LIST OF VALID AIP SUPPLEMENTS

AIP SUPPLEMENT

32. A.N.R. ROBINSON INTERNATIONAL AIRPORT (TTCP)

Establishment of New Taxiways, Apron and Terminal Building at the A.N.R. Robinson International Airport

AERODROME
CHART - ICAO

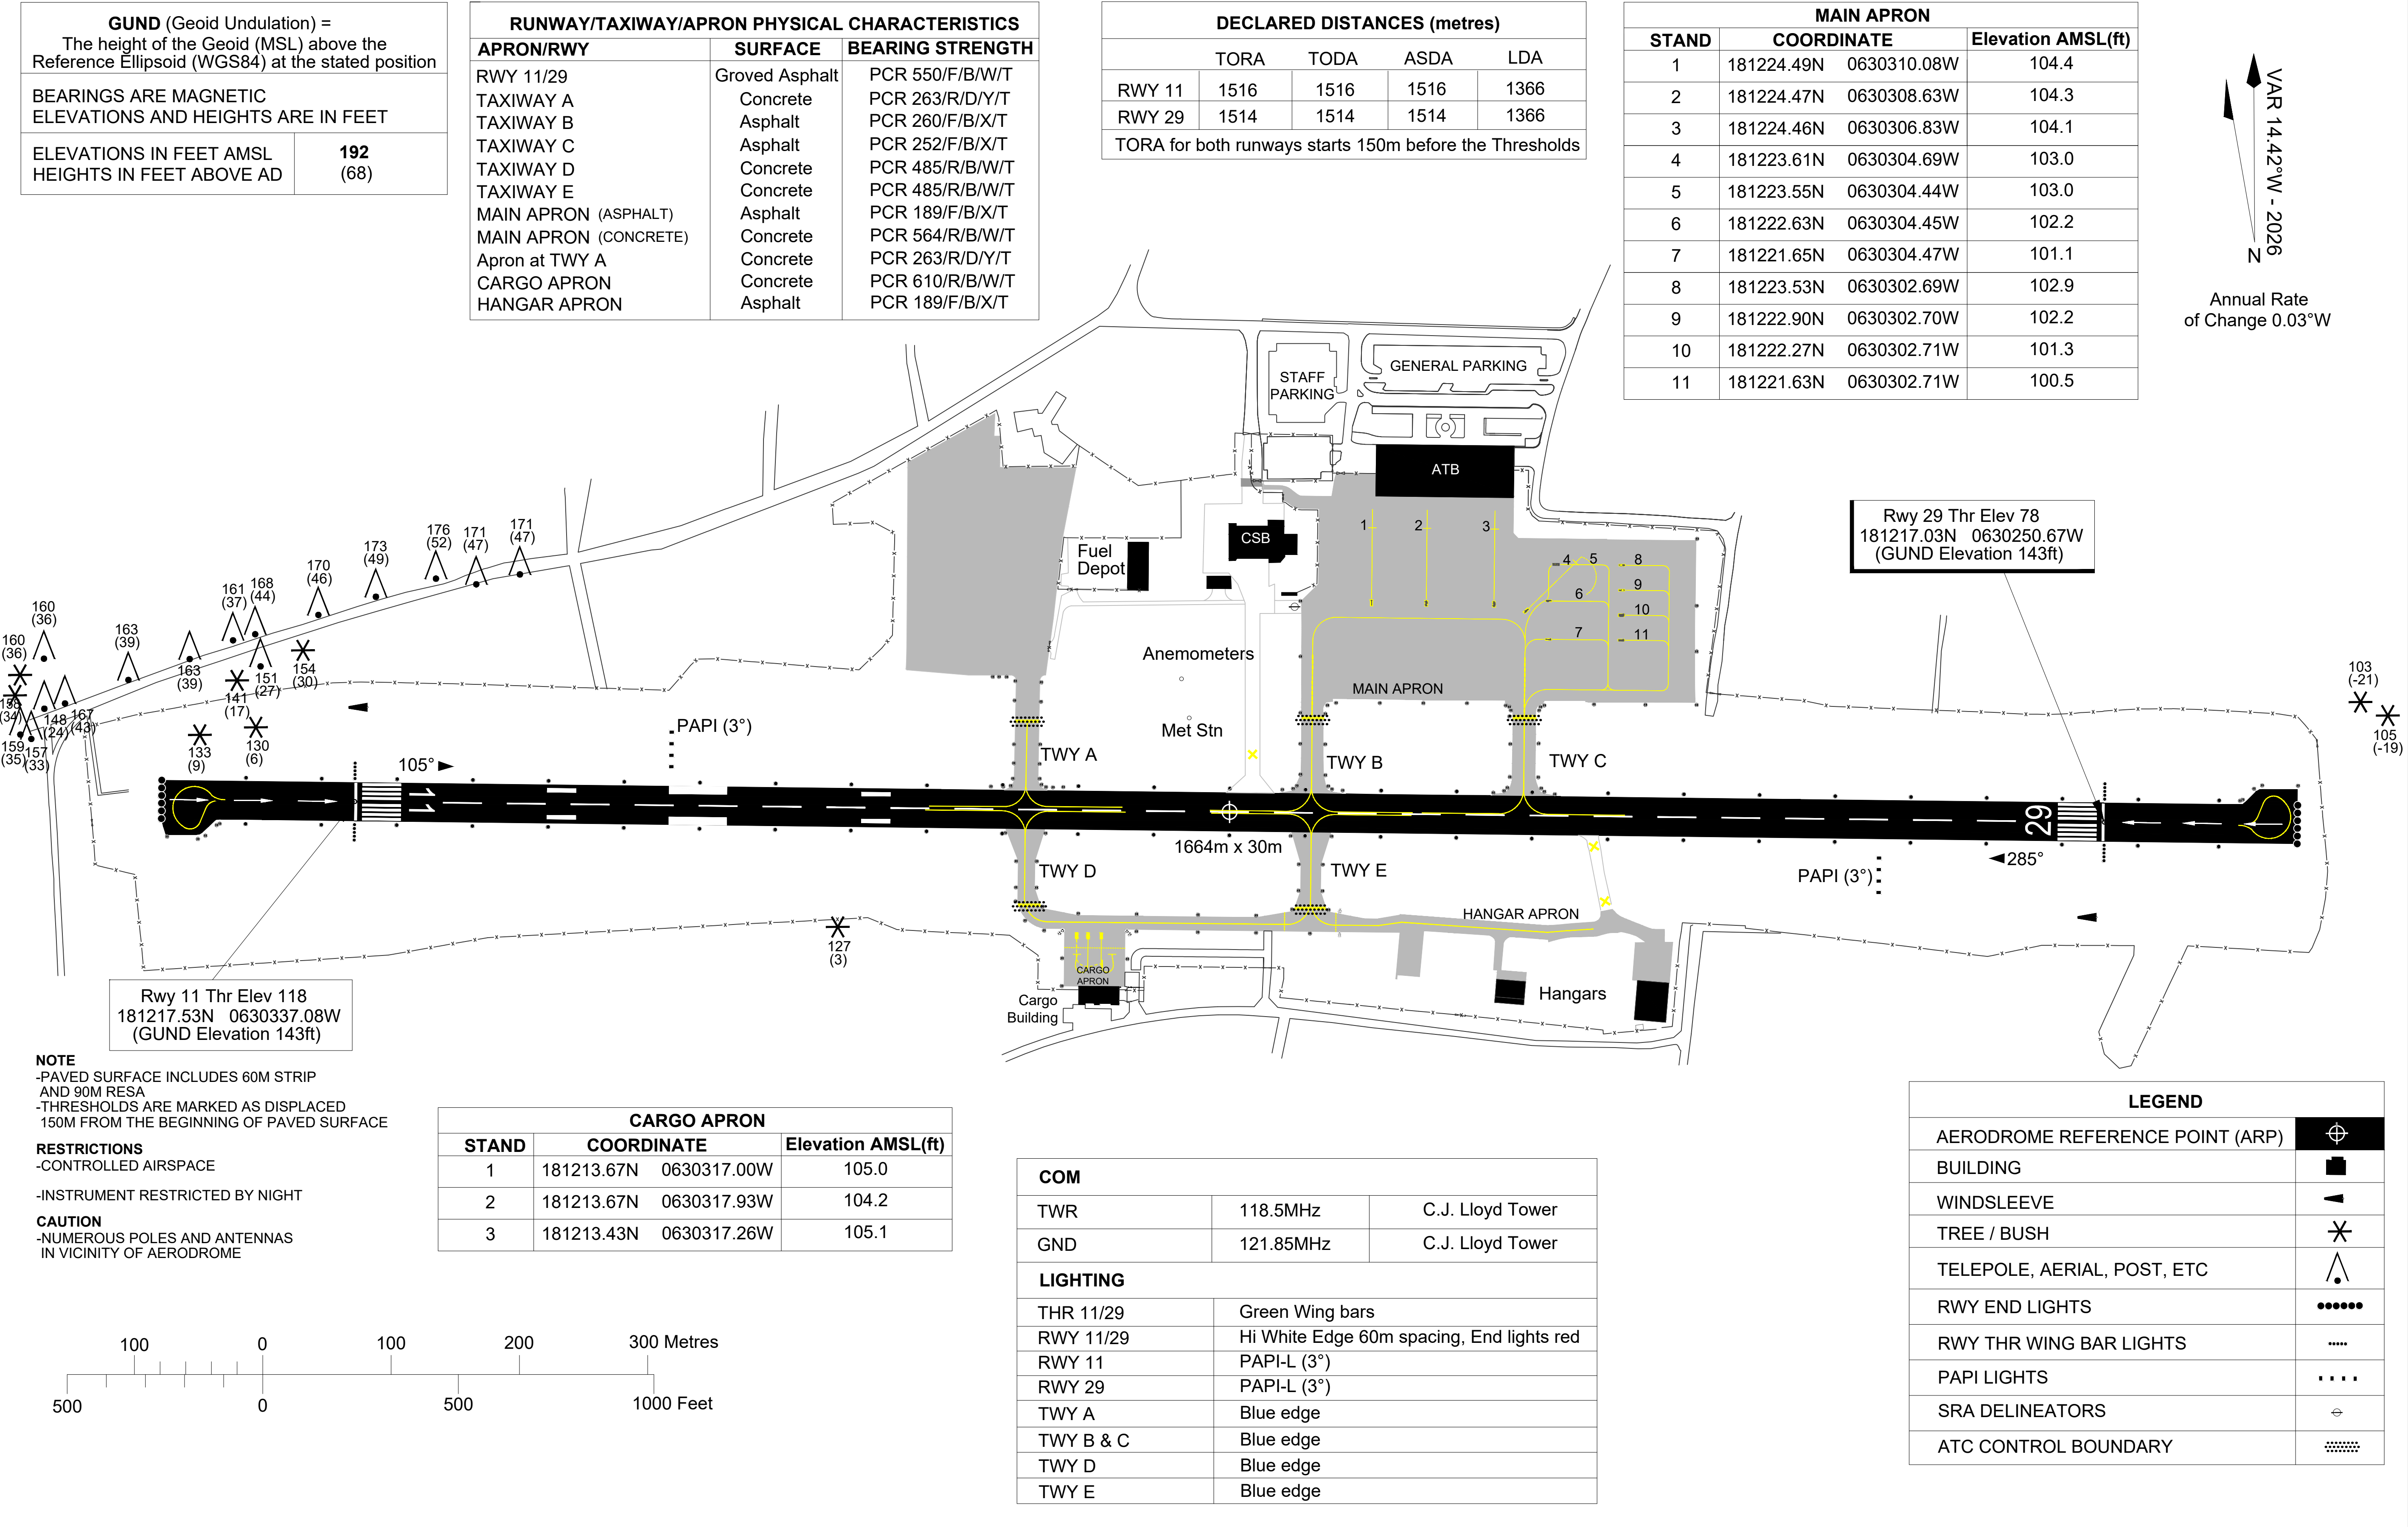
The Aerodrome Chart, Aerodrome Obstacle Chart and aerodrome data for the Clayton J. Lloyd International Airport have been updated.

AERODROME OBSTACLE CHART - ICAO
TYPE A - OPERATING LIMITATIONS

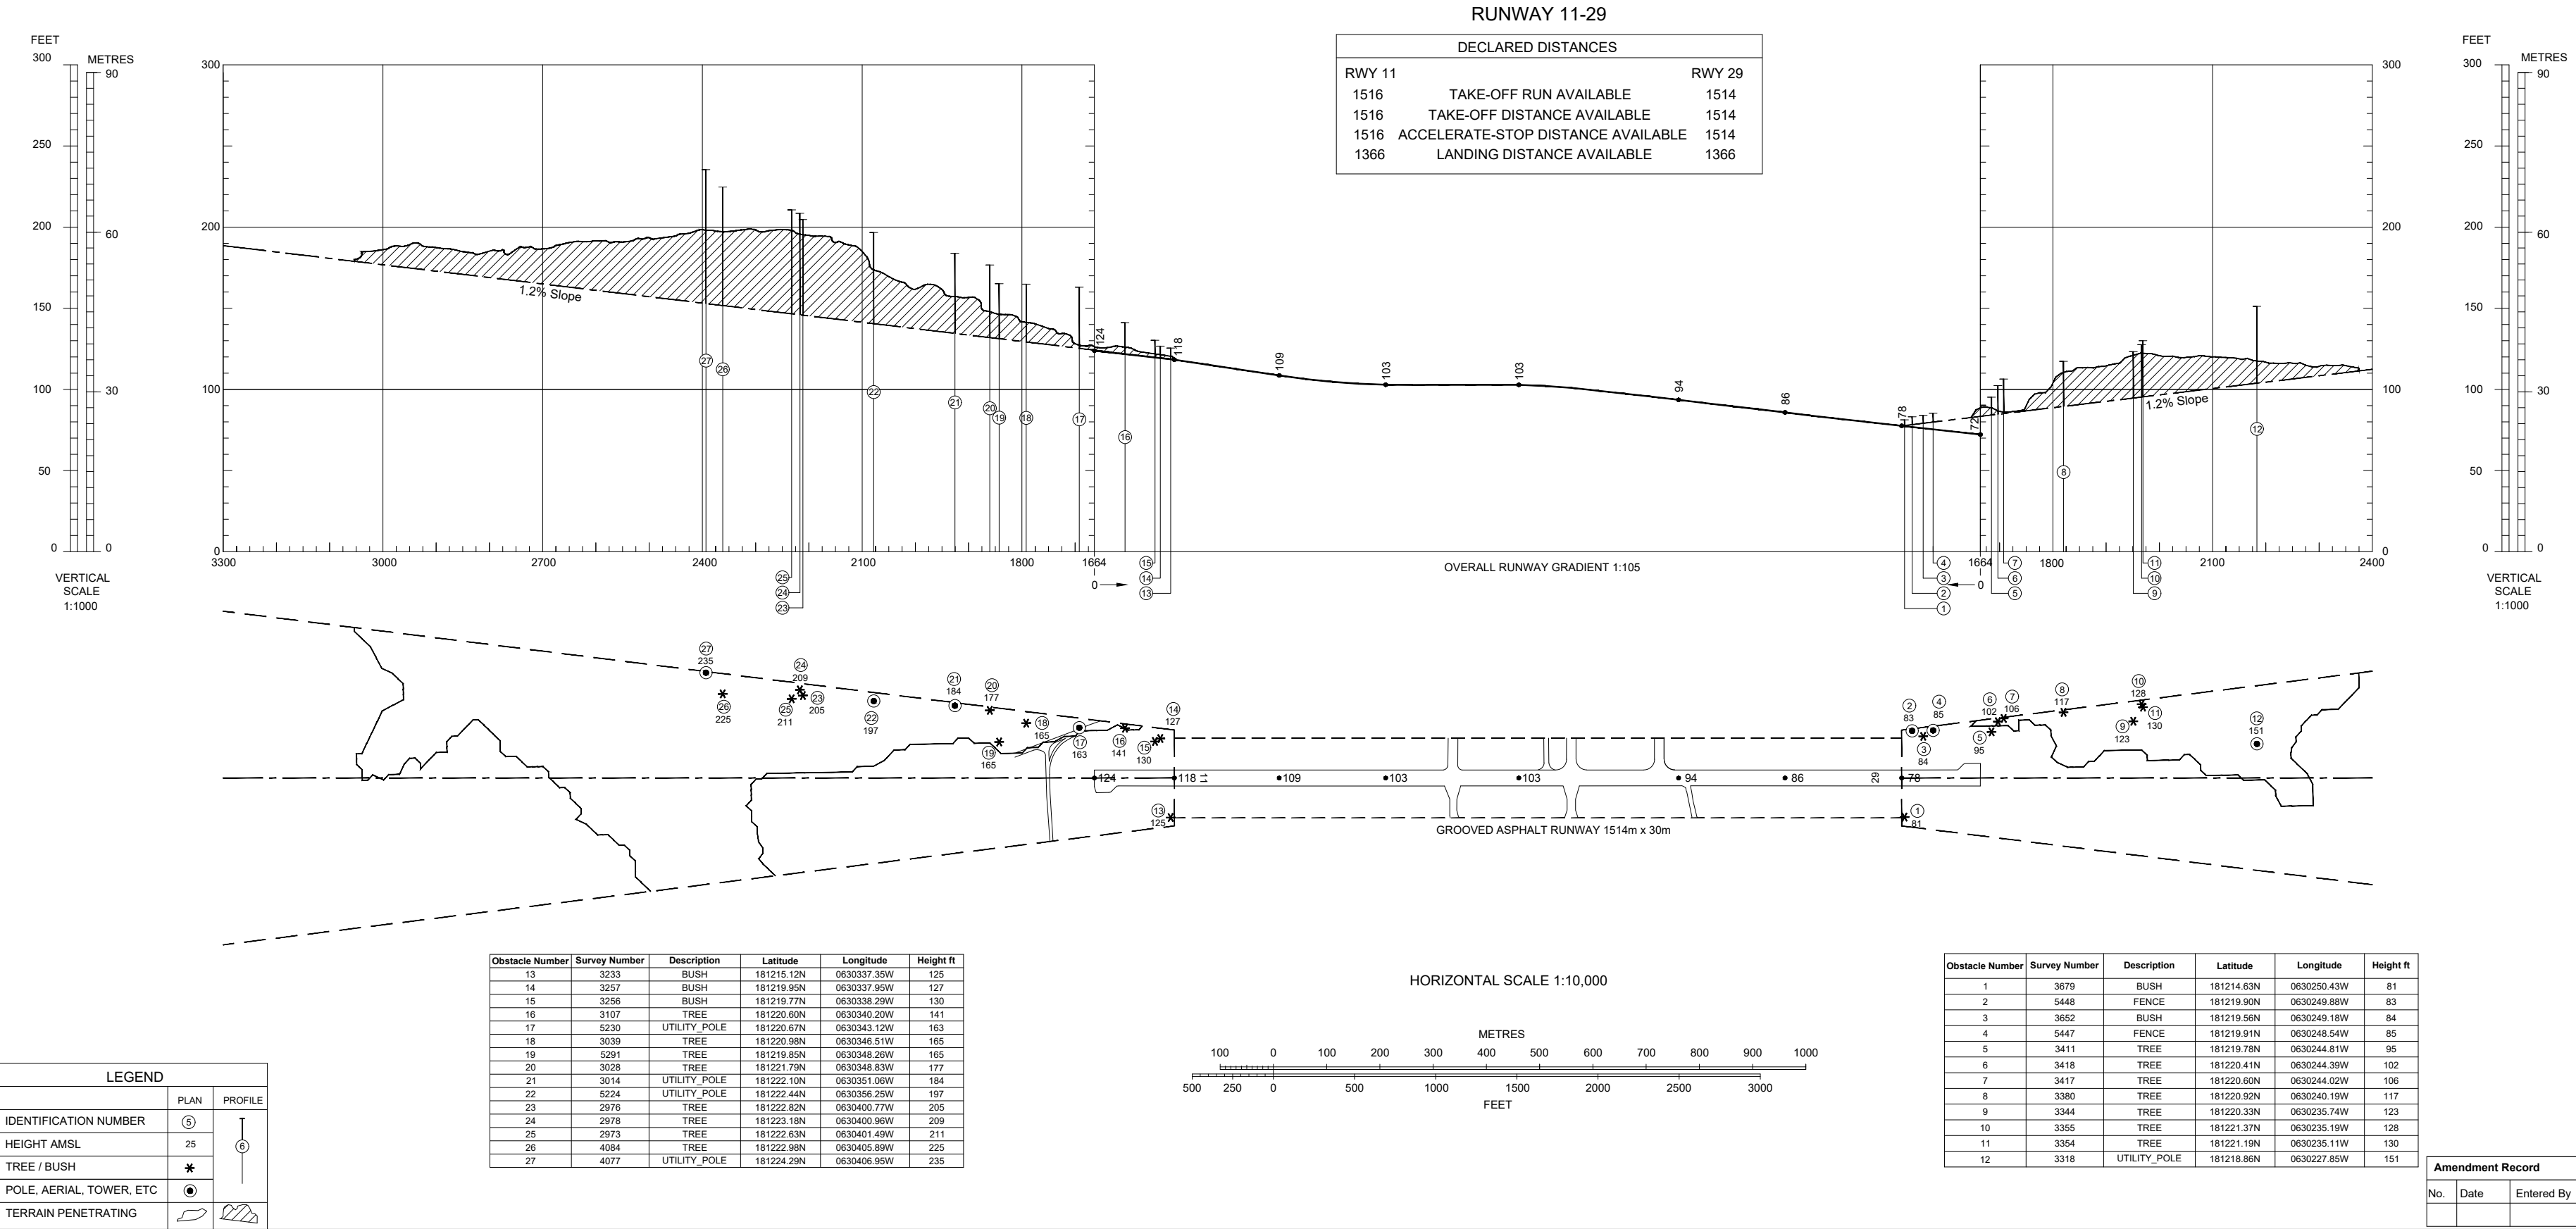
CHANGE: Updated Obstacles

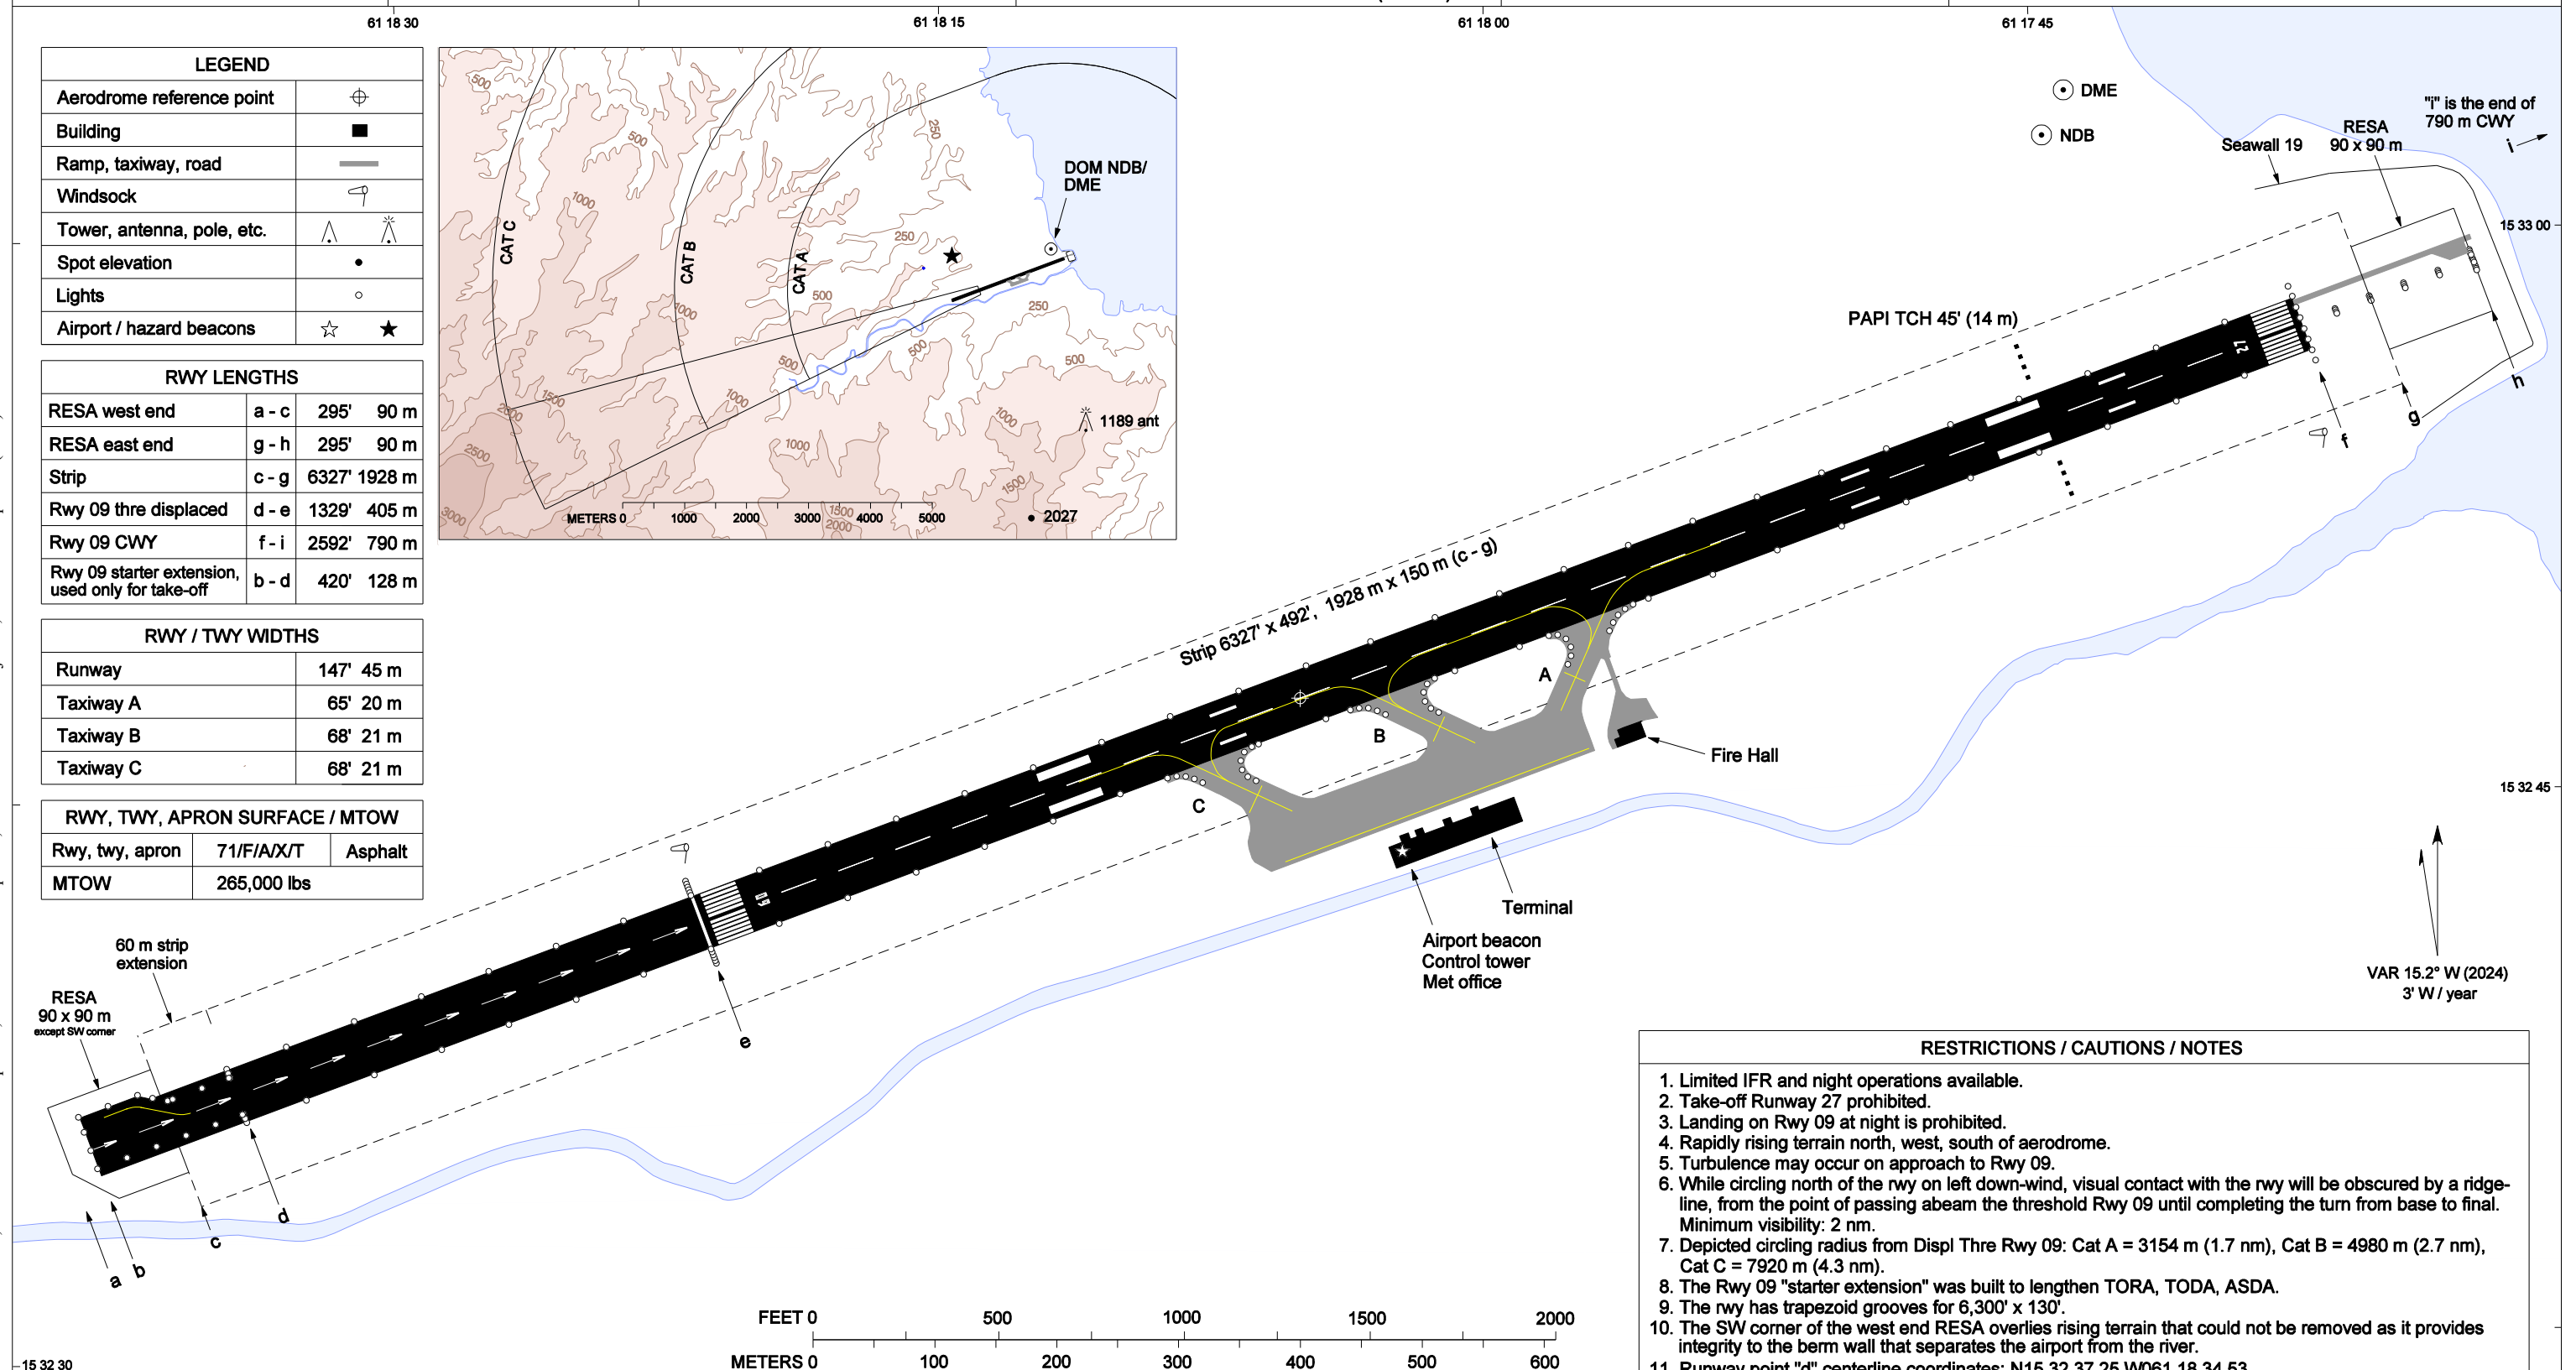
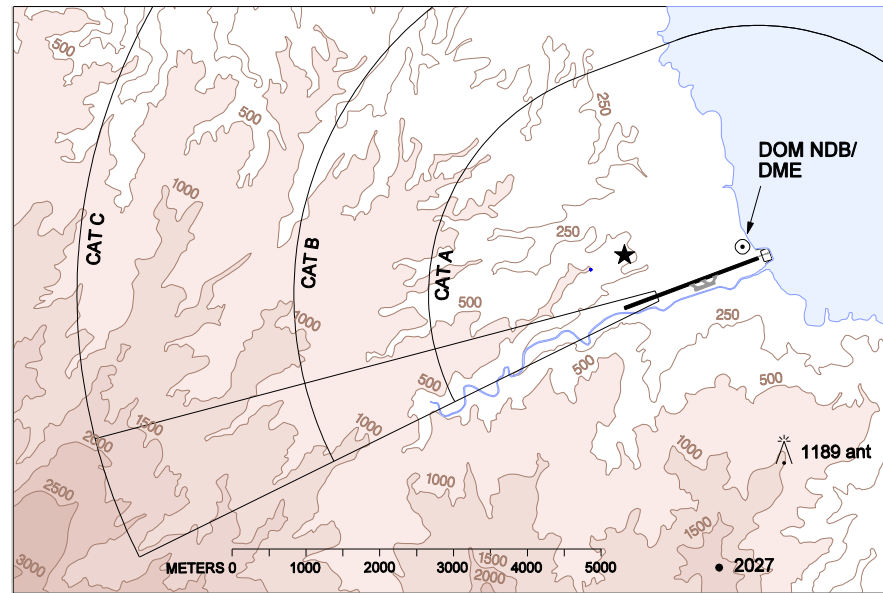
CHANGES: RWY extended to the West, Declared Distances updated, West End RESA updated, RWY and AD Elev adjusted, MAG VAR updated (2024).
